**Re: 2021 Annual Geotechnical Inspection Report for the Doris and Madrid Sites, Hope Bay Project, Nunavut**

**Attention**      **Nancy Duquet Harvey**  
**Subject**        **Doris and Madrid - 2021 Annual Geotechnical Inspections**  
**Project**        1CT022.077

## Summary of Primary Observations and Recommendations - Table 1: Doris Project - 2021 Annual Geotechnical Inspection

**Table 1 Agnico Response to 2021 Doris AGI Recommendations**

Survey Monitoring Points Displacement Timeseries

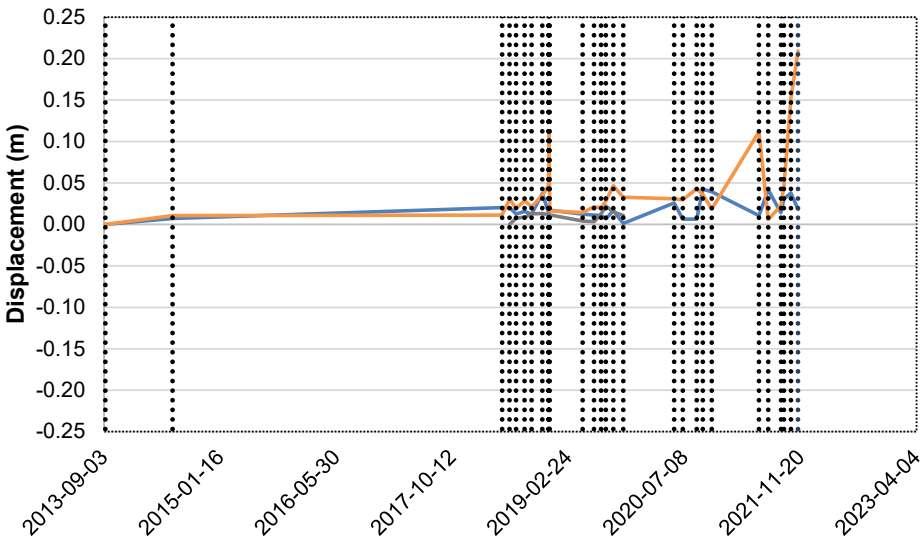
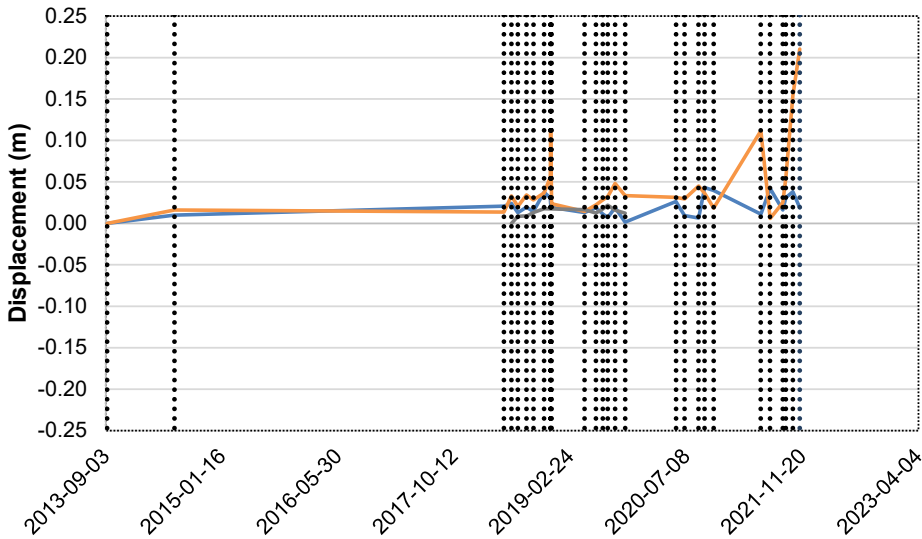
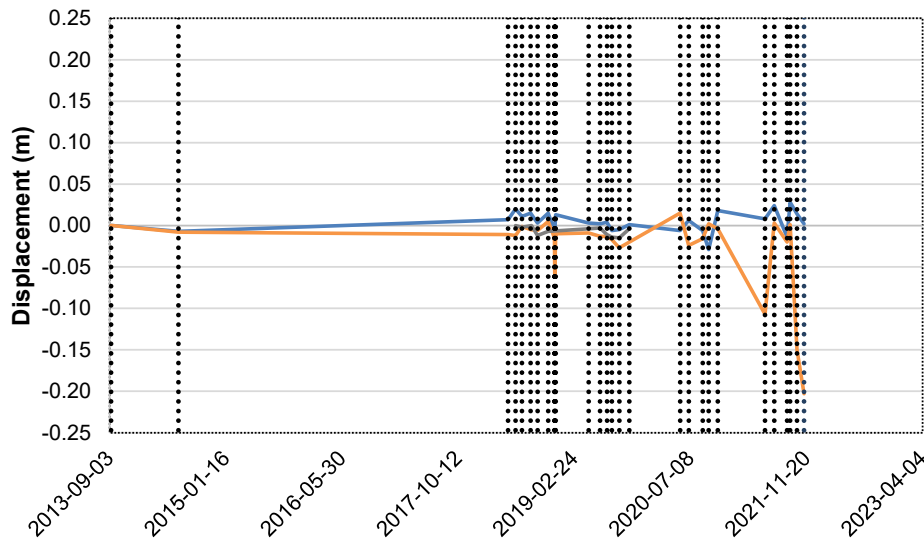
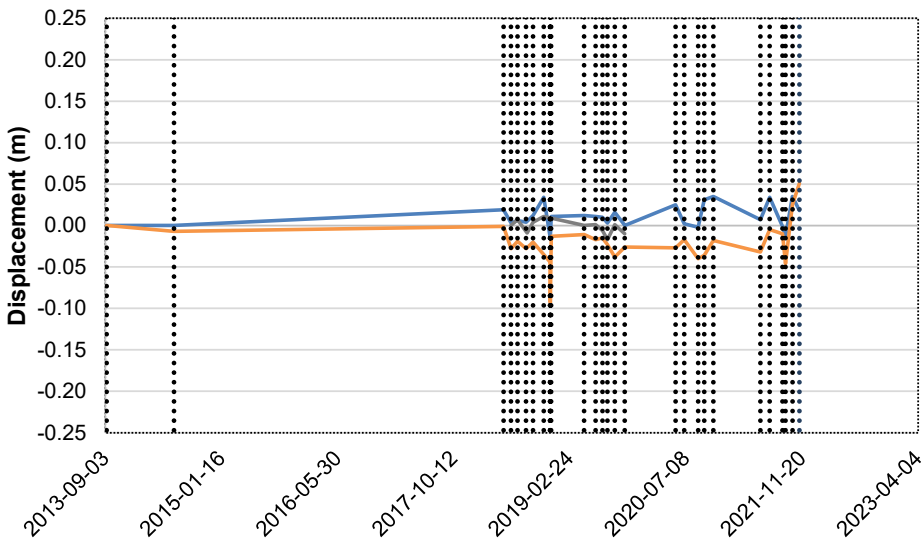
Observation	Comments and Recommendation
<p><b>PAD B</b></p> <p>Agnico Eagle has conducted surveys of the monuments on Pad B 2021. There was an improvement in the data collection in 2021.</p> <p>Horizontal displacement has been indicated by the last two surveys at Pad B (October and November 2021 - note this is after the AGI site visit, but data up until the end of 2021 was included in the data review when producing this memorandum).</p>	<p>The Pad B area should be continued to be monitored. The monuments should be resurveyed in May including a survey of the control point (CP1), and once the ground is snow free, the Pad B should be inspected for signs of tension cracking and the points PH1 and PH2 should be inspected for signs of accidental movement of the monitoring point itself.</p> <p>Attachment 3 presents a summary of the recent Pad B survey data.</p>
<p><b>DORIS CREEK BRIDGE ABUTMENTS</b></p> <p>The original rock gabion construction, done at each of the Doris Creek Bridge abutments, was done in a manner that deformed the welded mesh gabion cages (moved into place rather than built in place). The deformed state of the rock gabion cages makes it difficult to visually assess if ongoing deformations are occurring at these gabions.</p> <p>Review of the ground temperature cable (GTC) data at the Doris Creek Bridge location shows that there are no anomalous data suggesting any undue warming trend.</p>	<p>The abutment of the bridges should continue to be monitored. Specifically monitoring checks should look for any new or reoccurring depressions that might develop in the area.</p> <p>Permanent survey monitoring points should be placed near the corners of each rock gabion abutment. These points would allow monitoring of the abutments for movement and potential identification of the mechanism (tilting, vertical or lateral displacement). Surveys of these new monitoring markers are suggested to be completed at least in May and August 2022 to set up a monitoring baseline.</p> <p>At the time of the 2021 inspection no notable changes in the conditions around this abutment were observed since the last site visit.</p> <p>Attachment 4 includes an overview of the ground temperature data at the Doris Creek Bridge location.</p>

Inspection Item	Recommendation	Agnico Response
Pad B	The Pad B area should be continued to be monitored. The monuments should be resurveyed in May including a survey of the control point (CP1), and once the ground is snow free, the Pad B should be inspected for signs of tension cracking and the points PH1 and PH2 should be inspected for signs of accidental movement of the monitoring point itself.	Agnico will conduct additional surveys of Pad B at the outlined frequency in 2022.
Doris Creek Bridge Abutments	<p>The abutment of the bridges should continue to be monitored. Specifically monitoring checks should look for any new or reoccurring depressions that might develop in the area.</p> <p>Permanent survey monitoring points should be placed near the corners of each rock gabion abutment. These points would allow monitoring of the abutments for movement and potential identification of the mechanism (tilting, vertical or lateral displacement).</p> <p>Surveys of these new monitoring markers are suggested to be completed at least in May and August 2022 to set up a monitoring baseline.</p> <p>At the time of the 2021 inspection no notable changes in the conditions around this abutment were observed since the last site visit.</p>	<p>Agnico will continue to monitor the abutment of the Doris Creek bridge.</p> <p>Agnico has established survey monitoring points in 2021 and will continue to survey the monuments on the rock gabions of this bridge during the snow free period of 2022.</p>

Settlement Monitoring Plate  
Displacement Timeseries

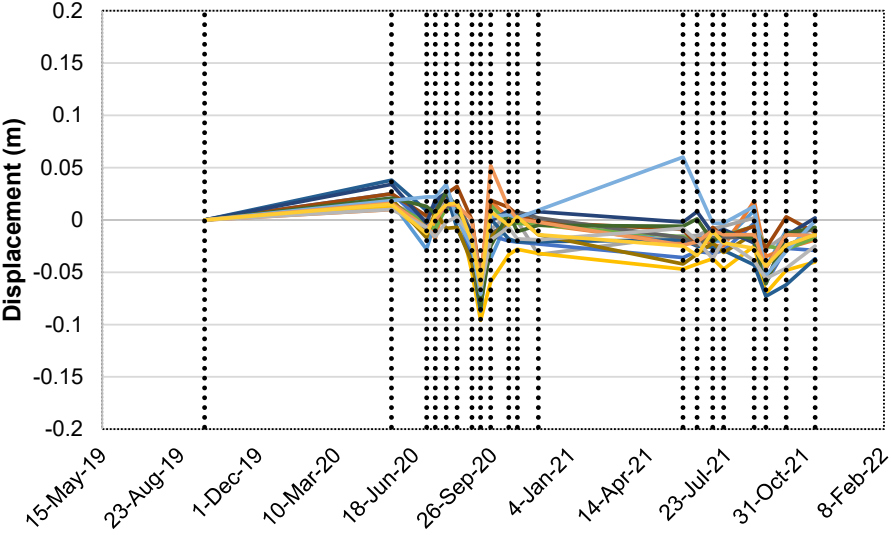
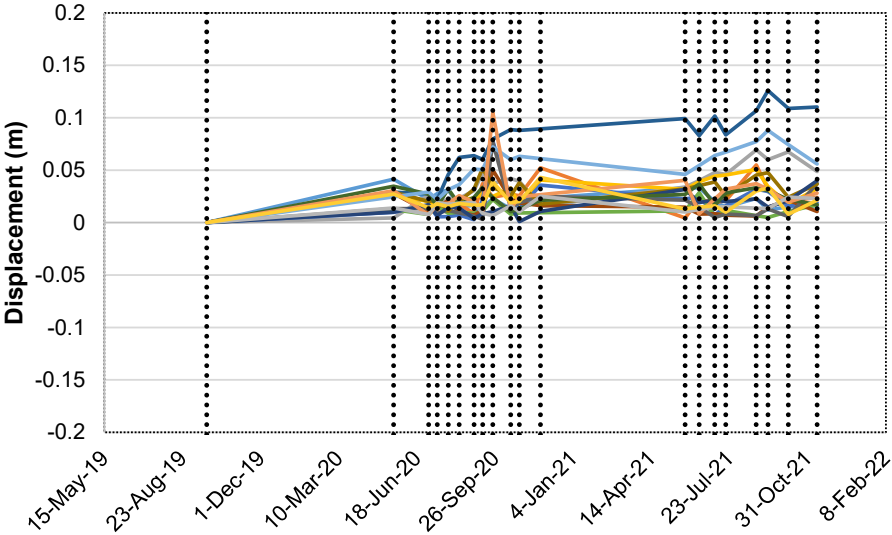
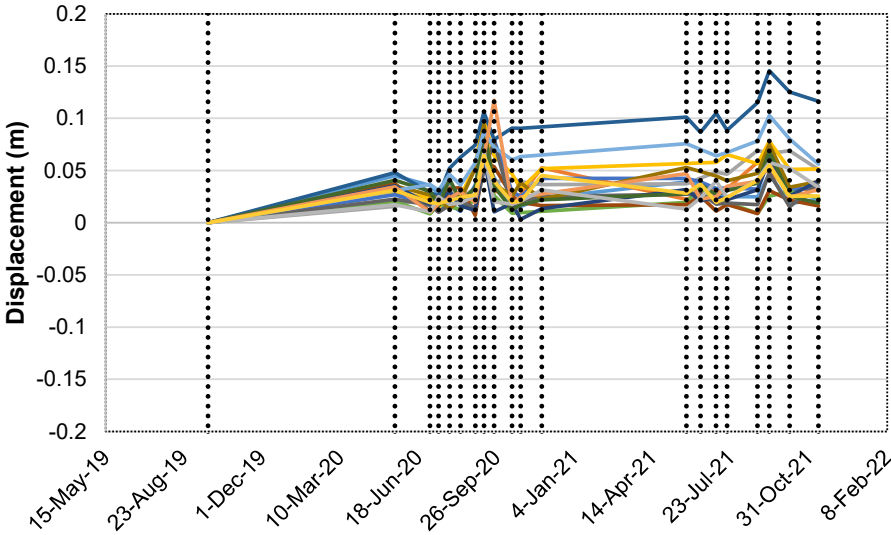
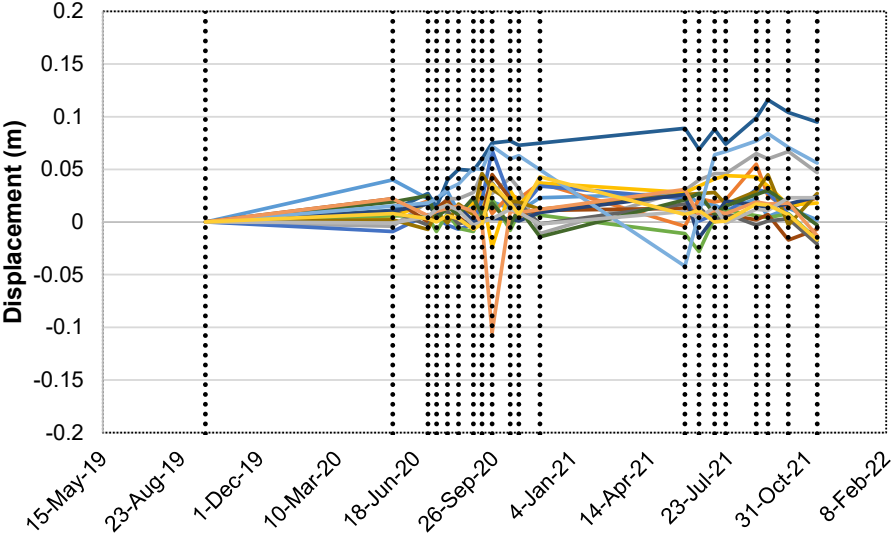
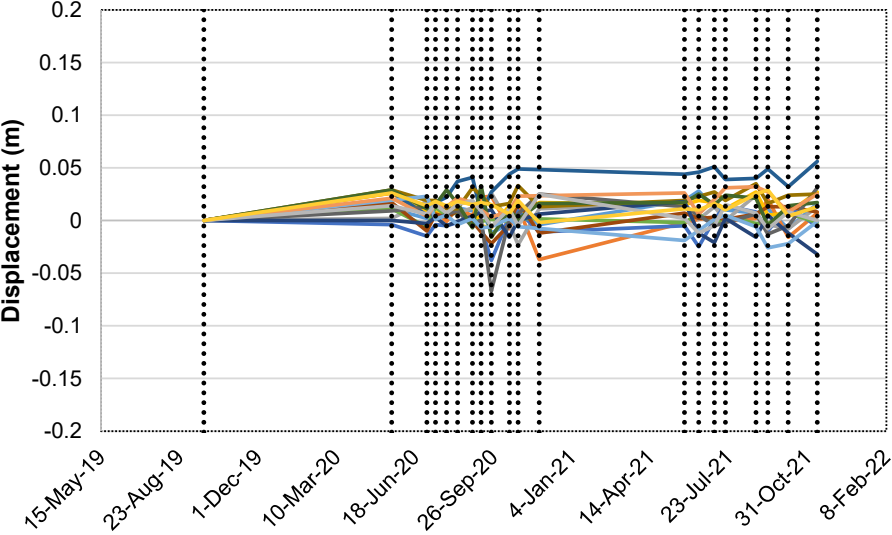
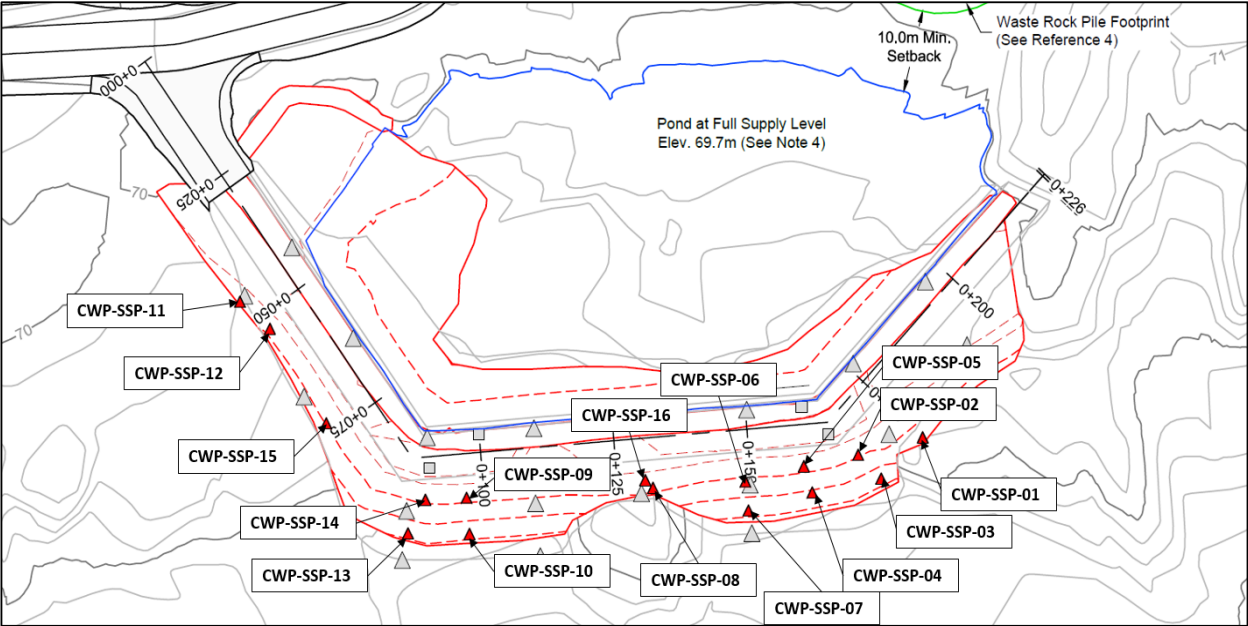
Observation	Recommendation
<p><b>MADRID NORTH – CONTACT WATER POND Survey</b></p> <p>Survey settlement monitoring plates and surface settlement points were installed in 2019 and should continue to be monitored at the Madrid North CWP.</p>	<p>Survey monitoring should continue at the Madrid North CWP from around May to December each year.</p> <p>Overall, the largest movements at the Madrid CWP correspond with the two areas where the foundation is on overburden permafrost. The current deformations are within design limits but should be continued to be monitored.</p> <p>An overview of the survey monitoring results from 2021 are presented in Attachment 3.</p>
<p><b>MADRID NORTH – CONTACT WATER POND Seepage</b></p> <p>Interim remediation measures (placement of fine overburden near the liner bedrock interface) were completed in late 2020 to help stretch out the seepage pathways below and at the liner to bedrock contact the CWP. This was suggested to help stretch out seepage pathways below the CWP. This has had some minor positive improvement but not eliminated the seepage noted from the CWP.</p> <p>The latest monitoring and visual inspections indicated that the main seepage pathway is most likely through the natural fractured bedrock at the liner tie in and further within the facility. Somewhat as expected, the seepage at this contact water pond is noted to increase with increased water levels (increased head).</p>	<p>The monitoring and diligent management of the Madrid CWP remains a top priority. The CWP should be operated as a 'dry pond' with any water being removed from the pond over the course of a few days or less. Ideally ponded water would be left in the pond for less than 48 hours.</p> <p>Seepage should be monitored below the pond (North), specifically around freshet. If any seepage is noted the flow rates should be estimated, the location should be marked (to look for potential deepening of the active layer in these areas) and periodic water samples should be collected and tested in accordance with site water sampling procedures (if possible).</p> <p><i>UPDATE: Issued for Construction (IFC) designs have been generated in 2022 (post the AGI inspection) and plans are in place to install a sump downstream of the existing Madrid CWP. This sump would be installed to assist with additional seepage control at the Madrid area.</i></p>

Inspection Item	Recommendation	Agnico Response
Madrid North – Contact Water Pond	<p>Survey monitoring should continue at the Madrid North CWP from around May to December each year.</p> <p>Overall, the largest movements at the Madrid CWP correspond with the two areas where the foundation is on overburden permafrost. The current deformations are within design limits but should be continued to be monitored.</p>	Agnico will conduct survey monitoring at the recommended frequency.
Madrid North – Contact Water Pond	<p>The monitoring and diligent management of the Madrid CWP remains a top priority. The CWP should be operated as a 'dry pond' with any water being removed from the pond over the course of a few days or less. Ideally ponded water would be left in the pond for less than 48 hours.</p> <p>Seepage should be monitored below the pond (North), specifically around freshet. If any seepage is noted the flow rates should be estimated, the location should be marked (to look for potential deepening of the active layer in these areas) and periodic water samples should be collected and tested in accordance with site water sampling procedures (if possible).</p> <p><i>UPDATE: Issued for Construction (IFC) designs have been generated in 2022 (post the AGI inspection) and plans are in place to install a sump downstream of the existing Madrid CWP. This sump would be installed to assist with additional seepage control at the Madrid area.</i></p>	Agnico has submitted Issued for Construction (IFC) for the construction of a sump downstream of the Madrid North Contact Water Pond. The installation is currently scheduled to occur prior to freshet 2022. This sump would be installed to assist with additional seepage control at the Madrid area.
